CONCEPT PLAN FOR
EBENEZER CHASE
 LAND LOT 304 & 304, 10TH DISTRICT, 2ND SECTION
 COBB COUNTY, GEORGIA

PETITION NO: Z-35

ZONING COMMENTS:

STAFF RECOMMENDATIONS

Z-35

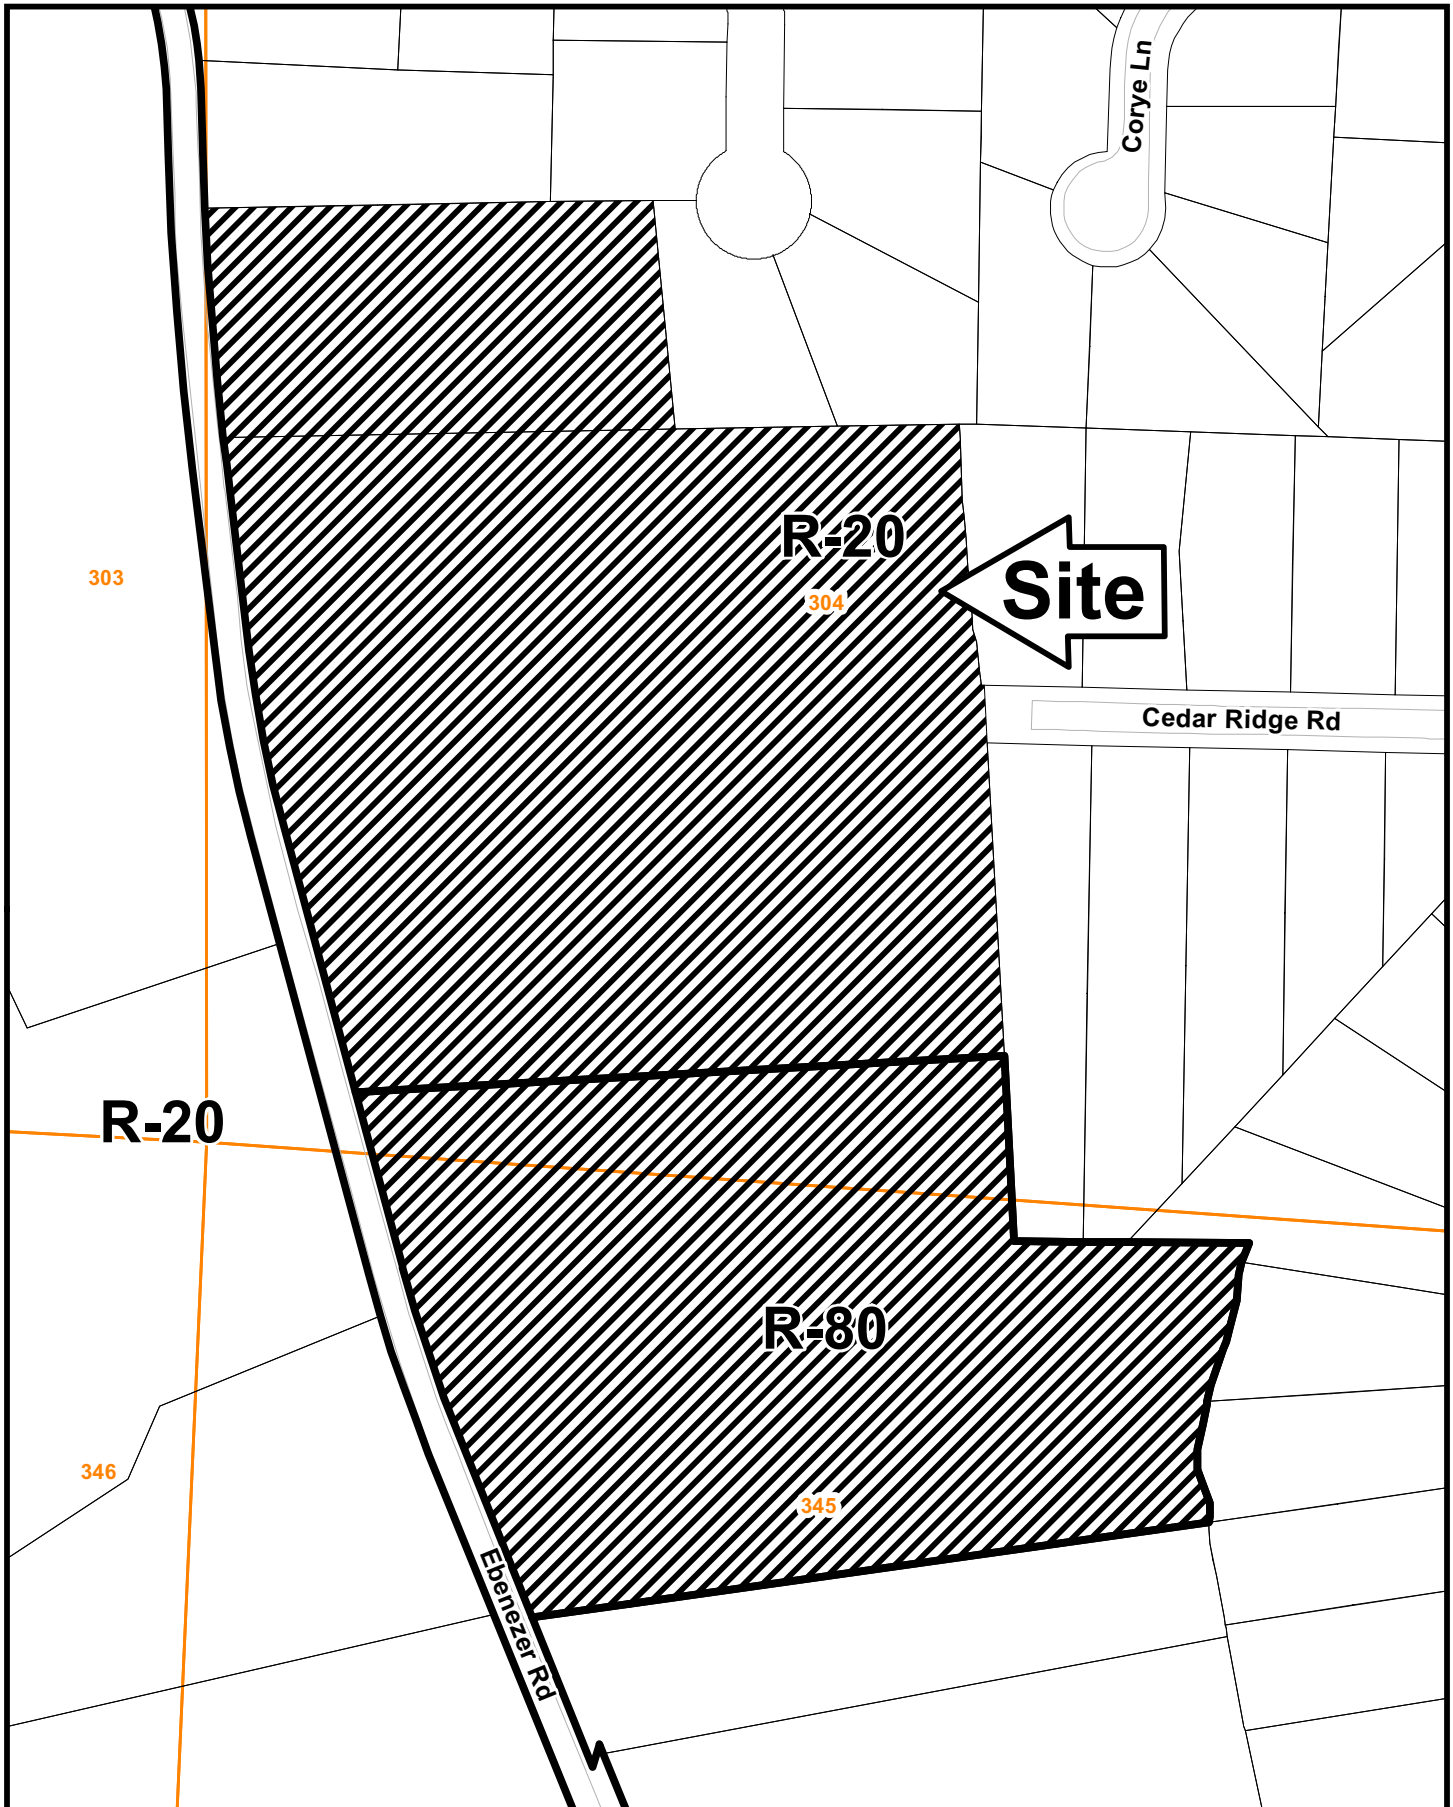
Applicant is requesting the Residential Senior Living (RSL) zoning district for the purpose of a 76-unit non-supportive senior living development. The units will be detached and arranged in quads. The units will be traditional one and a half stories, and will range in size from 1,750 square feet and up. Prices will range in from \$300,000 to \$450,000. The proposed development includes private streets, clubhouse and pool. The site plan indicates the required 20-foot landscape buffer abutting more restrictive residentially zoned properties.

1. This site is located to the west of Ebenezer Road between its intersections with Blackwell and May Breeze Roads. It abuts Princeton Manor Subdivision to the north and North Ridge (aka Heritage Farms) Subdivision to the east and south. The site is primarily pasture with small wooded areas along the fence rows and the northern and southern boundaries. Average slopes on the site range from 5 to 15%. The majority of the site drains to the east into and through the North Ridge Subdivision via an existing channel platted as a drainage easement. A very small portion of the northwest corner of the site (1.3 ac) drains across Ebenezer Road to the Phillips Farm property to the west.

2. Development of this project will result in an increase in impervious coverage, storm runoff and non-point source pollution compared to build-out under the current single-family zoning categories. To mitigate, the First Flush Water Quality Best Management Practice Requirements must be elevated to the 1.5-inch rainfall event and each larger storm discharge controlled not to exceed the allowable discharge of the next lower, more frequent storm event (ie. 5-year storm event released at 2-year rate; 10-year event at 5-year rate; etc. to 100-year event at 50-year rate).

3. Pervious pavers may be required for selected areas to meet the 55% impervious coverage limit.
